REMARKS

Applicant presented claims 1 through 35 for examination. In the above-identified Office Action, the Examiner has rejected all of the claims, and has disapproved the proposed drawing.

By this amendment, Applicant has added claims 36-46, enclosed a declaration of Professor Richard J. Samuels, and submitted a proposed drawing amendment to Figure 8. Subject to the approval of the Examiner, it is respectfully requested that the new drawing sheet be substituted for the originally filed drawing sheet for FIG. 8. Accordingly, claims 1-46 are now in the application. Applicant believes that no new matter has been introduced by the amendment and no additional fees are required for the application.

FIG. 7

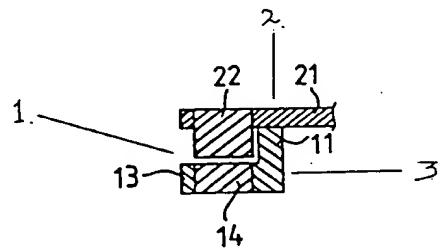
In the second half of the fourth paragraph on page 3 of the Office Action, phrases added in pages 2 and 3 of the original specification were considered new matter. Applicant again respectfully disagrees.

On page 3, Applicant added the following paragraph:

In one embodiment, as shown in FIG. 7, magnetic members 14 and 22 are not in contact with each other; magnetic members 14 and 22 are engaged with, but not supported on, each other. Instead, the arm 21 securing the magnetic member 22 is supported on an upper side portion of the primary spectacle frame 10. As shown in FIG. 7, the upper side portion can be an upper part of the side portion securing the projection 13.

The above paragraph cannot be considered new matter because at least it is supported by FIG. 7 of the original specification. To more clearly show that no new matter has been introduced, Applicant has separated the above paragraph into the following sections.

- (1) Magnetic members 14 and 22 are not in contact with each other; magnetic members 14 and 22 are engaged with, but not supported on, each other.

(2) Instead, the arm 21 securing the magnetic member 22 is supported on an upper side portion of the primary spectacle frame 10.

(3) As shown in FIG. 7, the upper side portion can be an upper part of the side portion securing the projection 13.

In one embodiment, each of the above sections is identified in FIG. 7 as shown in the following drawing:

Thus, the original FIG. 7 clearly supports all three sections. Regarding section 2, it is also supported by the original claim 1.
